MEMORANDUM

To: City of Scottsdale, Planning & Development Services
From: Lauren Proper Potter, Huellmantel & Affiliates
Re: 9-ZN-2021 – Palo on 75th 1st Review
Date: January 12, 2022

COMMENTS FROM 2ND SUBMITTAL 10/05/2021

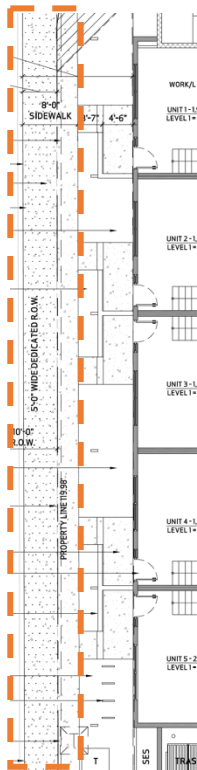
- The 2nd submittal site plan appears to indicate columns supporting the upper level balconies encroaching into the requested 8-foot sidewalk width on 75th Street. Please revise the applicable plans to remedy this situation so that a minimum 8-foot clear width is provided.

The 8' public sidewalk is measured to the outline of the upper level projection and the columns supporting the 2nd level balcony are set back from the face of the projection, resulting in a sidewalk that is greater than 8' as measured to the columns. The images below demonstrate that the measurement is taken to the face of the building projection at the 2nd level with the columns located closer to the ground floor building face and not interfering with the 8' clear distance for the public sidewalk:

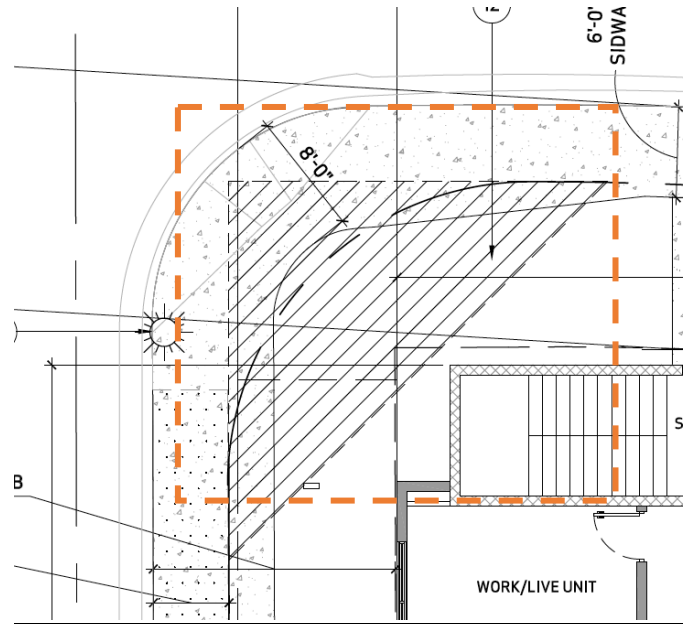
- The 2nd submittal site plan indicates that the portion of sidewalk at the intersection of 75th Street & McKnight will remain as-is. The sidewalk in this area should be replaced with a larger landing area at the intersection, similar to the sidewalk landing on the northeast corner of 75th & Main Street. Please revise applicable plans accordingly. The site plan has been updated to reflect a larger landing area on the sidewalk at 75th Street and McKnight Avenue as shown in the image below:

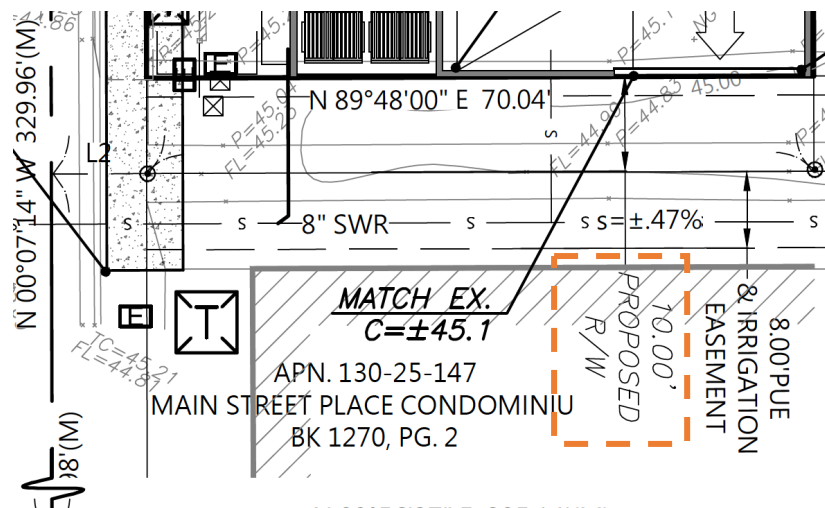
- Though indicated on the site plan, the preliminary G&D plan does not show the required 10-foot fee-title alley dedication. Please revise the G&D plan accordingly. The Grading and Drainage plan has been updated to reflect that the alley will be a 10' right-of-way dedication as shown below:

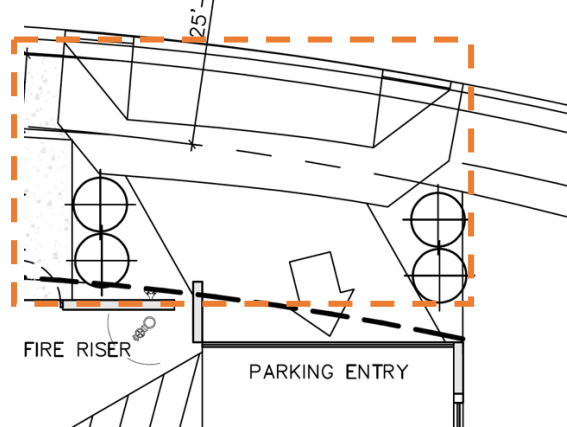
- *From 1st review, the driveway, including wings, cannot extend past the property line into the adjacent right-of-way. Please update applicable plans to indicate the driveway, including wings, will be wholly aligned with the project's parcel boundaries. Refer to Section 5-3 of the DSPM.*

The site plan has been revised to indicate that the driveway, including wings, does not extend past the property line as shown in the image below:

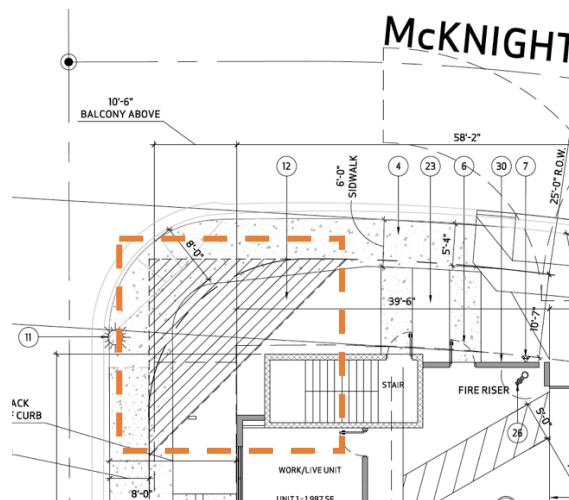
- *Transportation does not support a detached main public sidewalk along 75th Street, as it still appears as if the sidewalk is intended to be a “private” space for the residents. From 1st review, the main public sidewalk should be 8 feet wide and attached to the street curb. Please revise the site plan accordingly. If the developer wishes to have a separate sidewalk abutting the building for residents only, that is fine. Additionally, scooters and unmotorized bikes are permitted on sidewalks and being that this sidewalk is along a street with a 25 MPH speed limit, separation from street curb is not necessary. To discuss in more detail, contact Phil Kercher (480-312-7645 or pkercher@scottsdaleaz.gov). Refer to Section 5-3.110 of the DSPM.*

The site plan has been revised to reflect an attached sidewalk along 75th Street as shown in the image below:

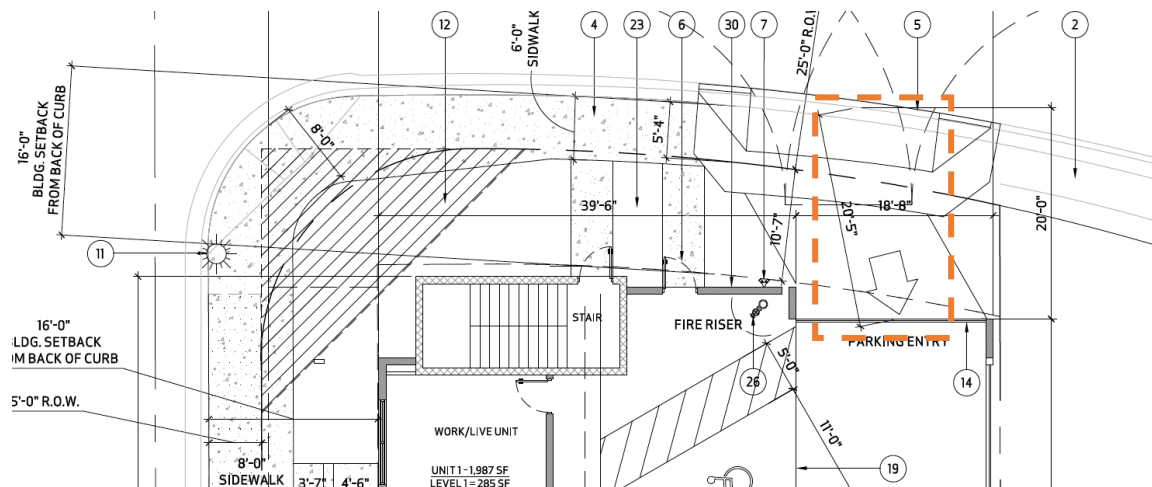
- *Please revise the applicable plans to indicate a minimum setback of 20 feet from back of curb to the proposed gated entry. Refer to Section 2-1.302 and Figure 2-1.2 of the DSPM.*

We have discussed this guideline with Greg Bloemberg and Phil Kercher as it relates to the challenges presented by the site's narrow configuration while maintaining the property owner's desire to access-control the parking area. We are able to provide 20'-5" from the back of the curb to the gate, but it has been since pointed out to our team that the requirement is 20' from the back of the sidewalk.

As a compromise, the property owner will provide a gate that automatically opens (but does not remain open) during business hours to allow unrestricted access to the work/live space to address concerns over access. Additional justification is provided in the revised Project Narrative provided with this resubmittal, but the property owner has concerns with being able to prevent members of the public from utilizing the private parking spaces at Palo during high volume events in the area when public parking can be a challenge. Because Palo is a small-sale project that does not provide excess parking for the public, access control is an important component of ensuring adequate parking on site for future residents. We have increased the distance to the gate as much as possible and are proposing 20'-5" as shown below:
